# Naas Golf Club

23<sup>rd</sup> February 2006

**Re: Waste Licence Register No 47-2  
Nepin Trading Ltd  
Kerdiffstown Waste Disposal Facility**

**Drawing Number :** 05889

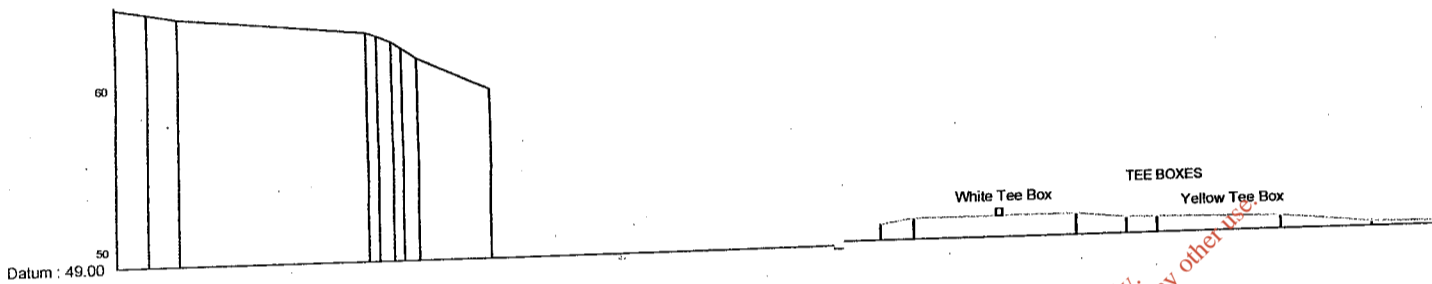
We attach survey which shows the fill in your site to be approximately 15 metres higher than our tenth tee box which is substantially higher (approx 11 metres) than your current EPA licence permits and also substantially higher (min 3 metres) than that for which you have planning permission. For us to establish levels has been made more difficult by our not having access to do a complete level survey, and had such access been available we are confident that as above the levels generally would be at substantial variance with the EPA licence and planning permission. In this context we note that the level survey which you promised us by the 27/05/05 in your letter of 20/05/05 has not been forthcoming.
